**JUNE 2021 FINAL MND SCH #2020100267**

**JUNE 2021 FINAL MITIGATED NEGATIVE DECLARATION/INITIAL STUDY  
FOR AMERESCO KELLER CANYON RNG LLC – PROPOSED RENEWABLE  
NATURAL GAS PROCESSING FACILITY AND PIPELINE PROJECT  
SCH #2020100267  
LAND USE PERMIT LP18-2022  
JUNE 23, 2021**

This document constitutes the Final Mitigated Negative Declaration/Initial Study (MND), State Clearinghouse SCH #2020100267, for the Ameresco Keller Canyon RNG LLC – Proposed Renewable Natural Gas Processing Facility and Pipeline Project (Ameresco RNGPFP) in unincorporated Contra Costa County near Pittsburg, CA. The proposed project is a renewable natural gas (RNG) processing facility (RNGPF) and pipeline that includes construction and operation of a new RNGPF and an underground transmission pipeline. The Final MND includes a revised project description, summary responses addressing the project description and potential impacts, the written comments received on the November 2020 re-noticed draft MND, responses to the comments received, and staff-initiated text changes including changes resulting from the preparation of responses to comments received and revised and/or deleted figures. The text changes are

**PLAT 6 - REVISED PIPELINE ROUTE SEGMENT 2  
ADJACENT TO PROPOSED STONEMAN PARK DEVELOPMENT**

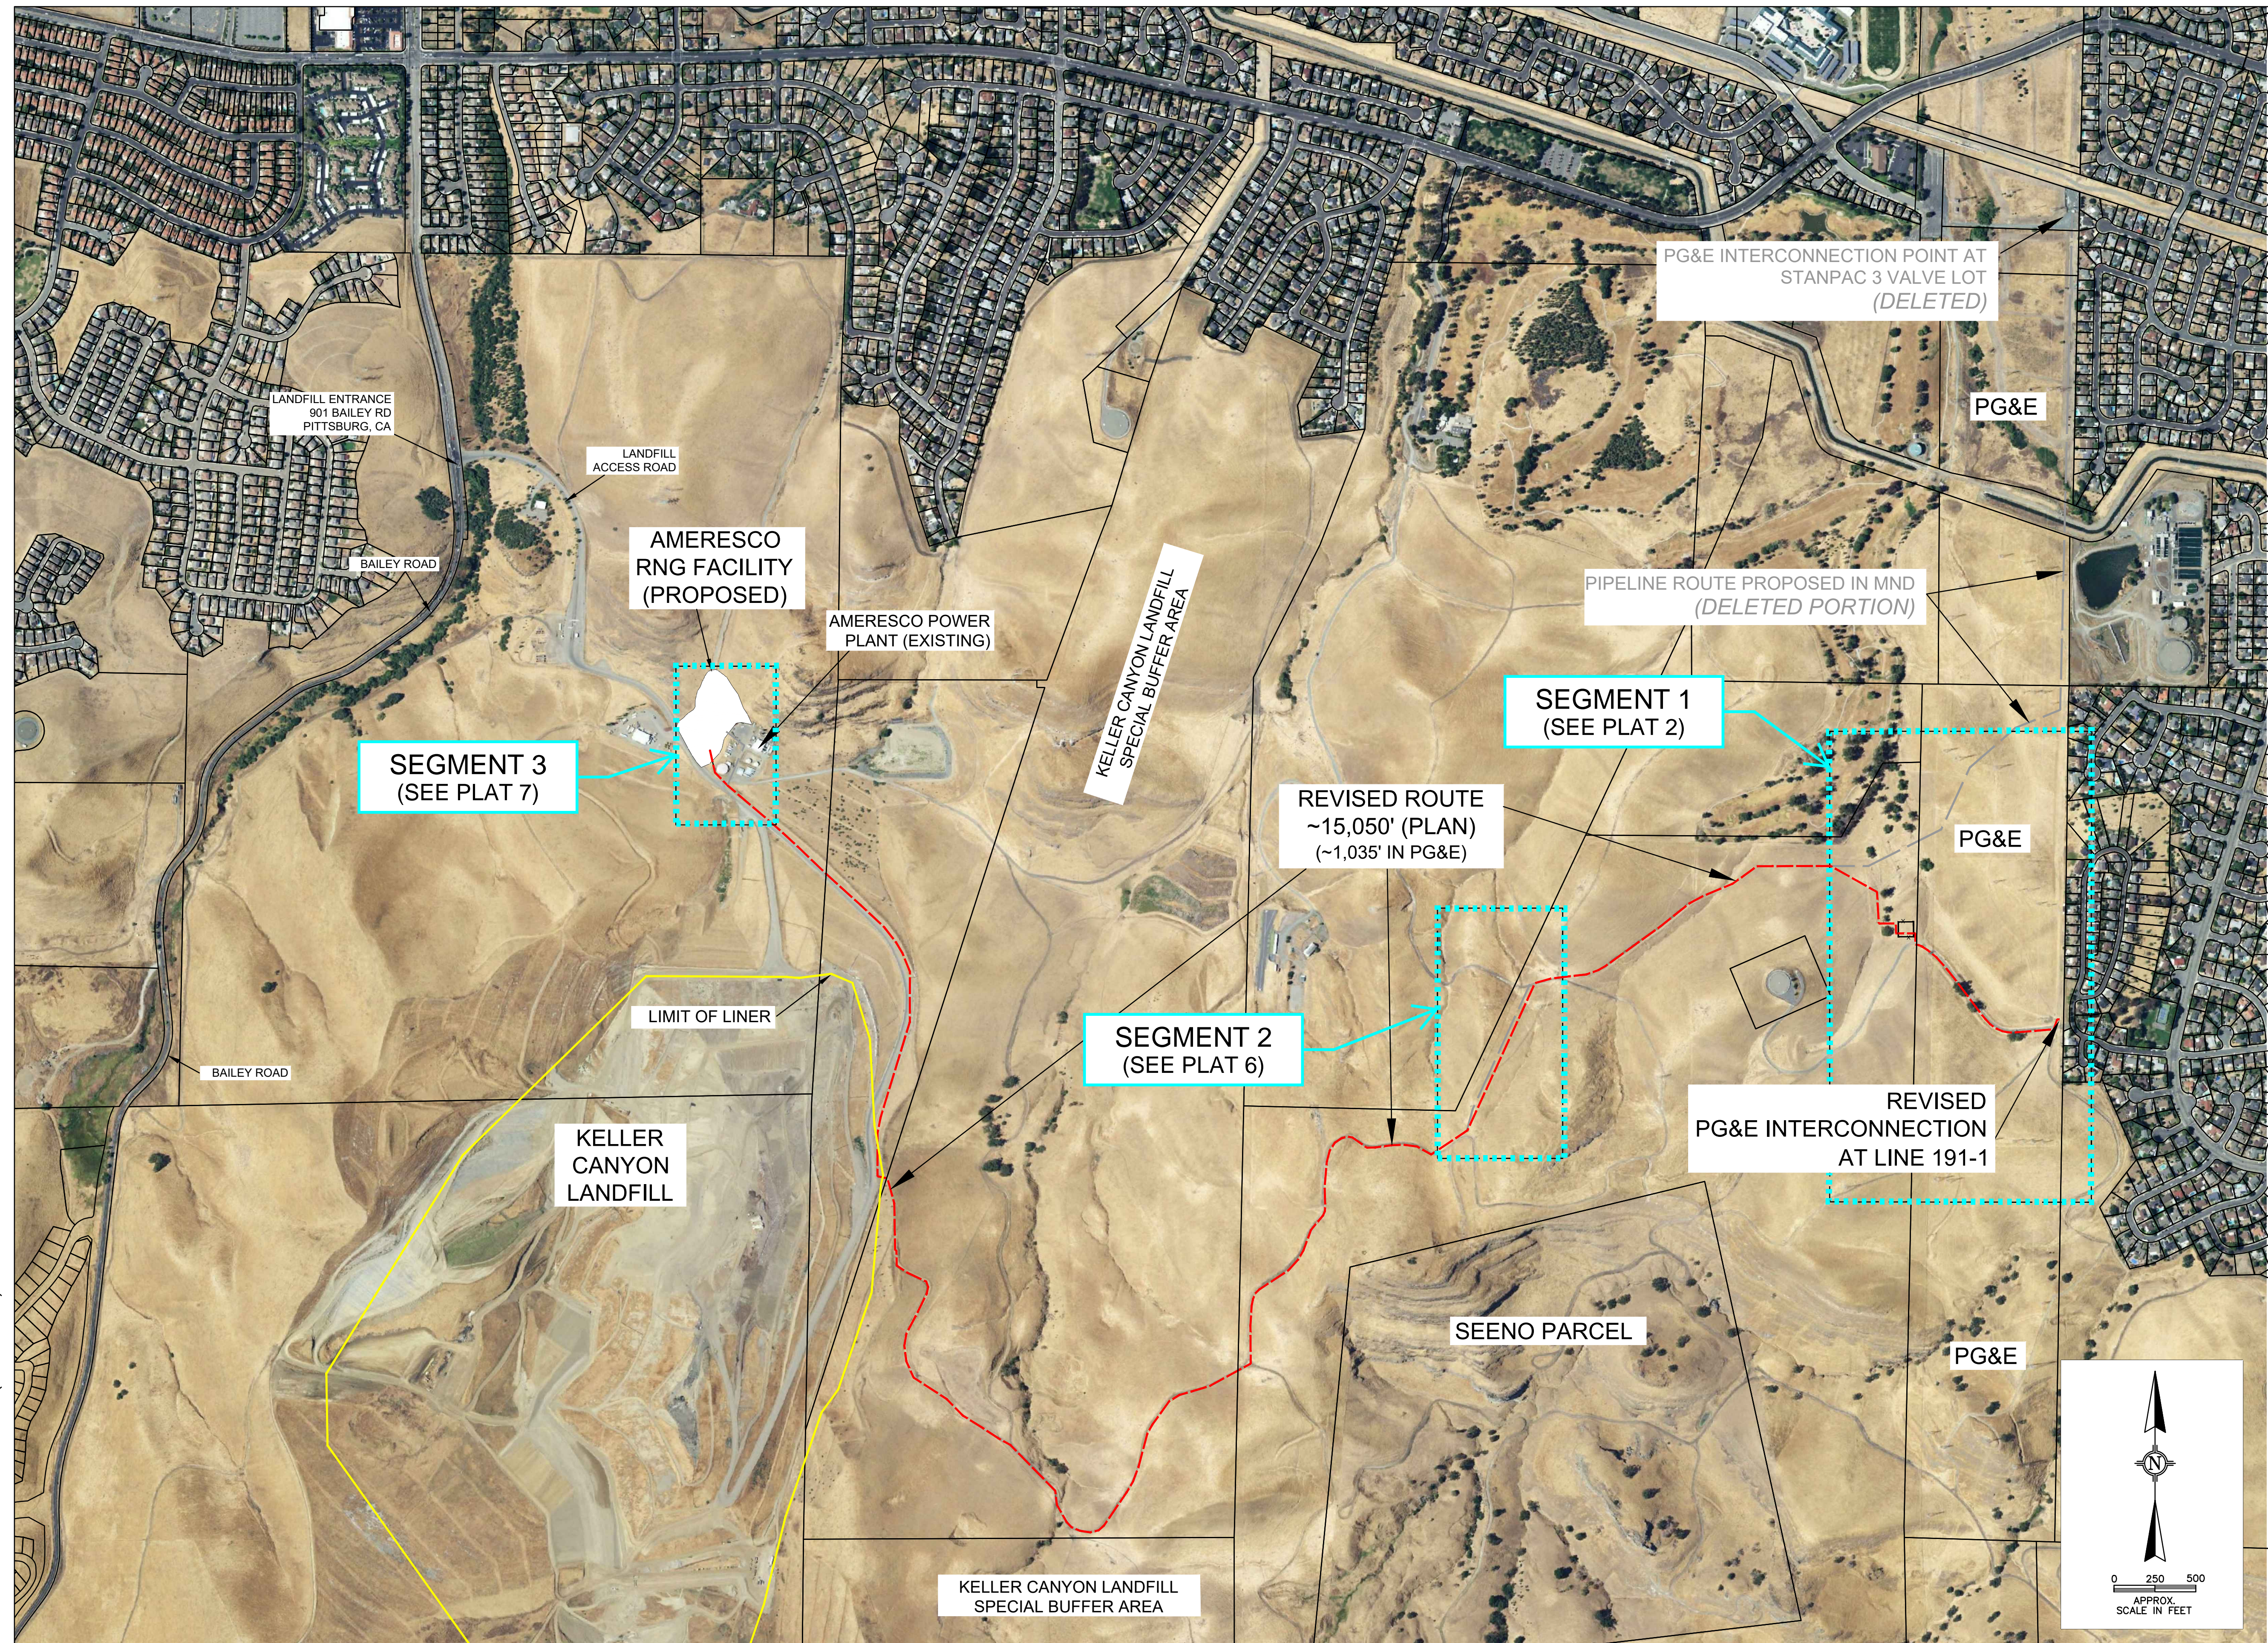
The RNG pipeline route adjacent to the proposed Stoneman Park has been revised in recognition of concerns expressed regarding the project's potential effects identified in comments on the draft MND. The revised segment is shown as a black dashed line on Plat 6. The revised segment creates additional physical separation between the RNG pipeline and the proposed Stoneman Park development. Separation would increase by 50 percent from 50 feet to 75 feet. The revised route places the RNG pipeline 20 feet outside of the new PIR of 55 feet. The revised RNG pipeline route

The RNG pipeline alignment proposed in the draft MND is shown as a blue dotted line on Plat 6. This alignment is situated about 50 feet east of the apparent property line indicated by an existing fence and has been deleted. The applicant was unaware of the proximity of proposed residential lots at the time the original alignment was established. The proposed Stoneman Park property is currently open space.

### PLAT 1 (REVISED FROM MND FIGURE 9) REVISED PIPELINE PLAN

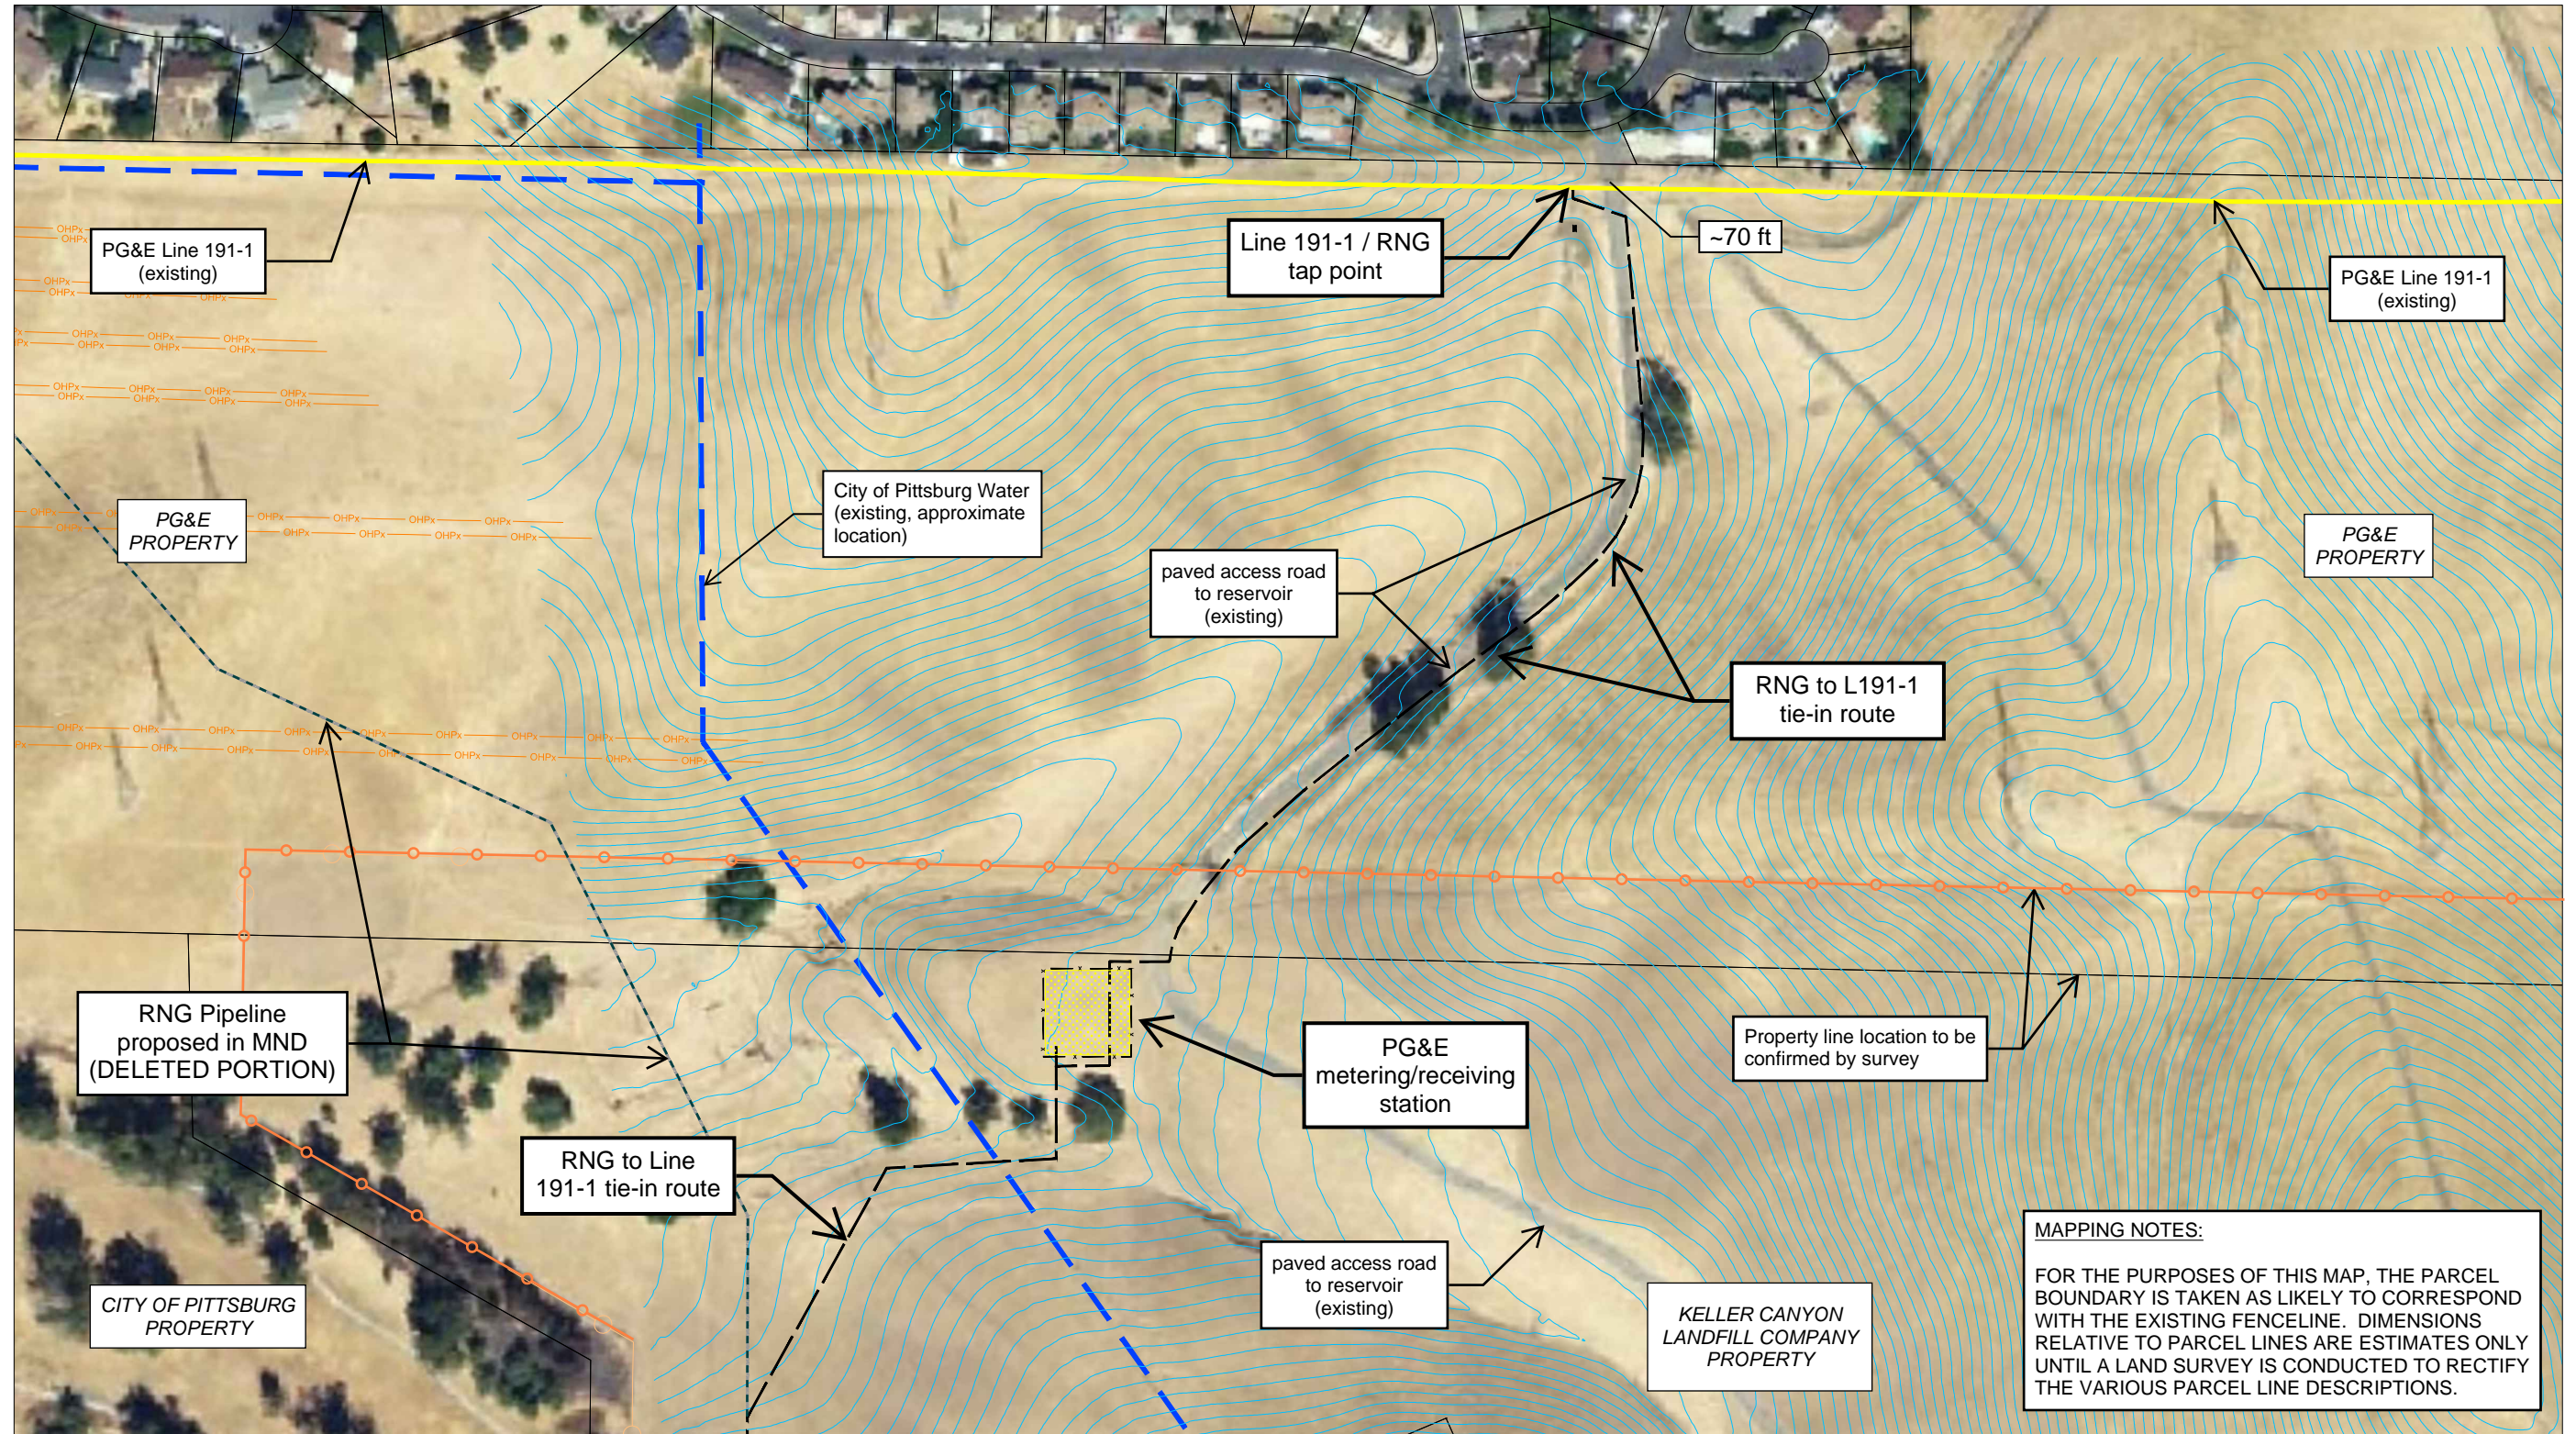
The Project Description in the draft MND includes a total of 18,030 feet (3.41 miles) of RNG pipeline. The three segments of the proposed RNG pipeline that have been revised are designated as Segments 1, 2, and 3 from east to west respectively. The general location of each segment is depicted on Plat 1 (a revised Figure 9 – Pipeline Plan from the MND). Details of each segment are shown on other plats as described below.

The RNG Pipeline would connect to the existing PG&E Line 191-1 approximately one mile south of the connection shown in the draft MND. The proposed routing of the RNG pipeline to the tie-in point is shown on Plat 2. The proposed revised route was developed in response to written comments received on the draft MND regarding potential project effects. In the revised project, Ameresco has eliminated the segment of the RNG pipeline that was previously proposed to run parallel to PG&E Line 191-1 within 50 feet of some residences. The former PIR of 72 feet extended into portions of backyards of some residences. This potential impact has been eliminated.

**PLAT 3**  
**PROPOSED METERING STATION (LOOKING NORTH)**

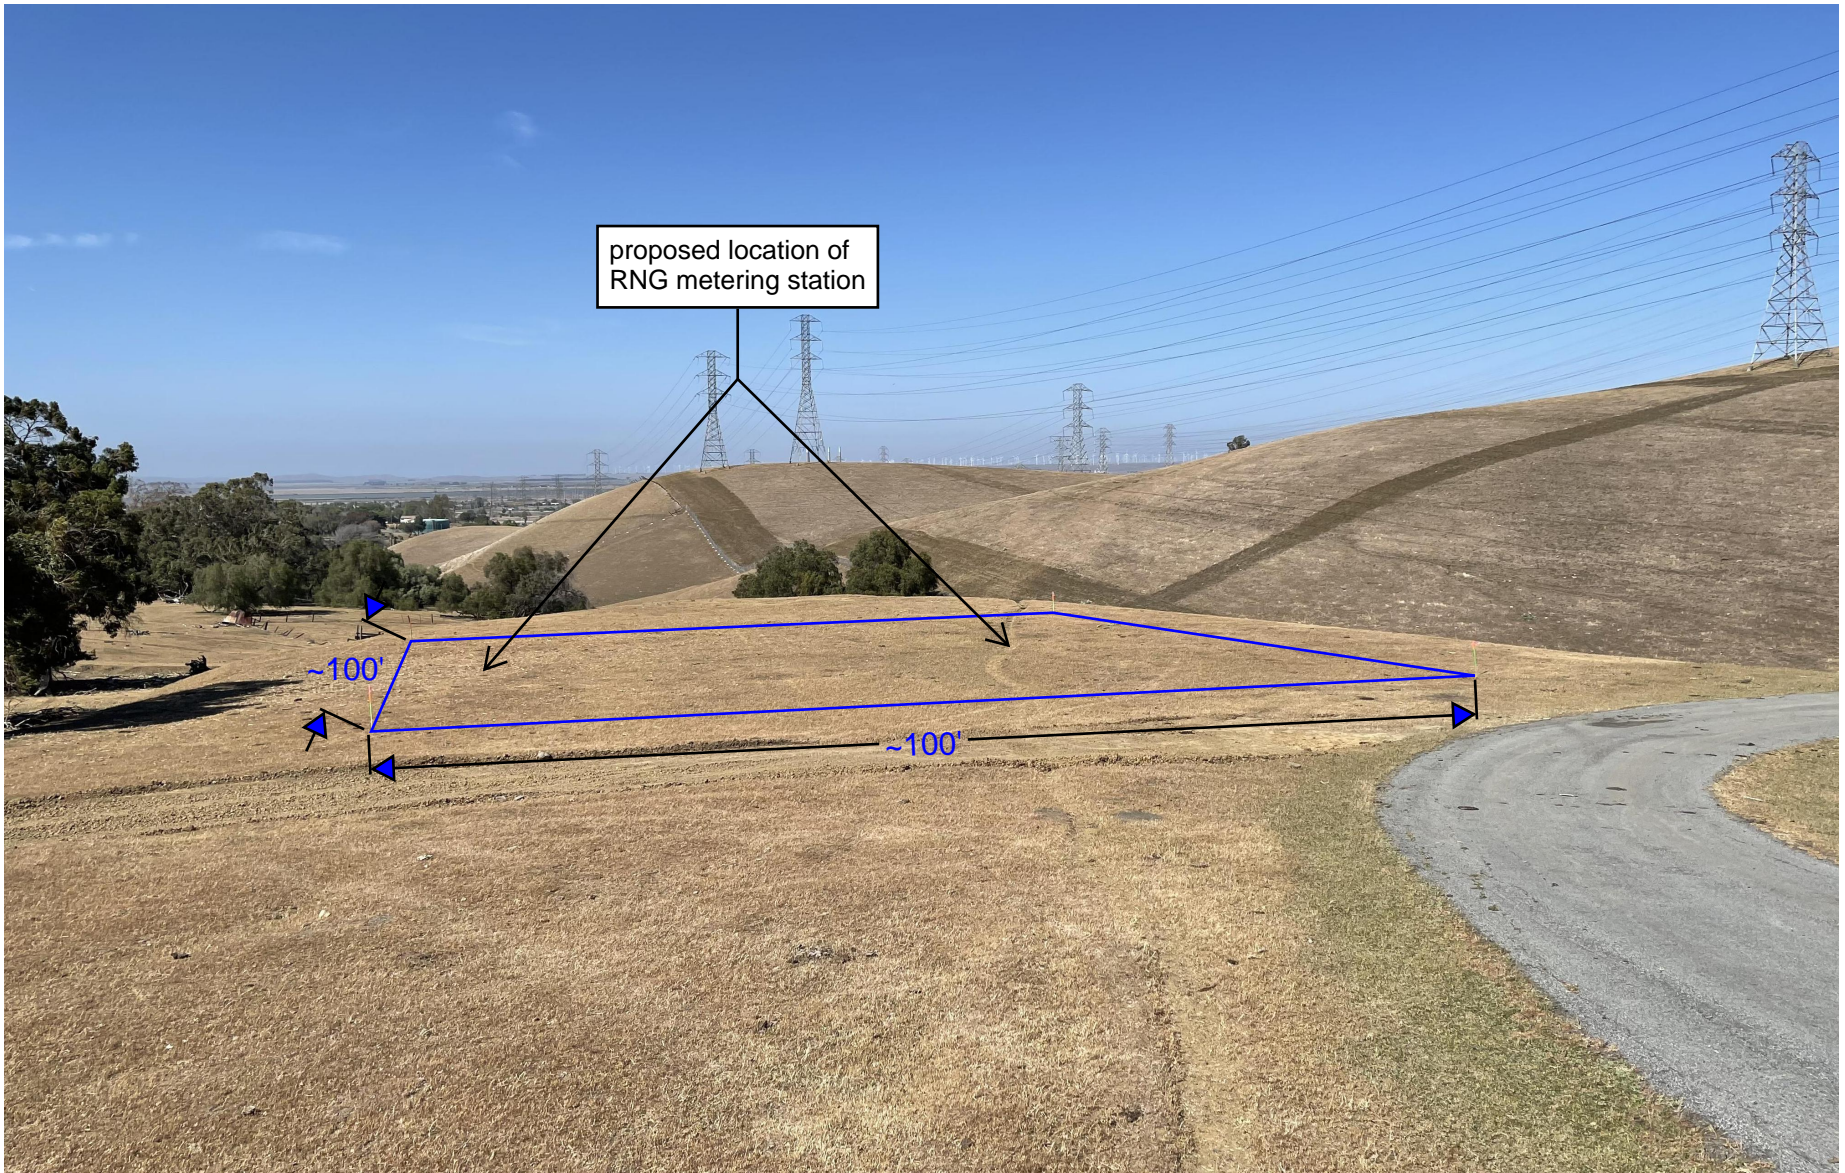
- Relocate the metering station from PG&E property onto KCL property, eliminating effects of close proximity of the metering station to nearby residences. The site for the metering station is an elevated plateau and is shown on Plats 2 and 3. The near-level ground surface of the plateau area appears to have been created prior to 1993, but subsequent to that area's use as a ranch/barn/corral beginning prior to the 1930's. The approximate boundaries of the metering station site are shown in a ground plane photograph on Plat 3.
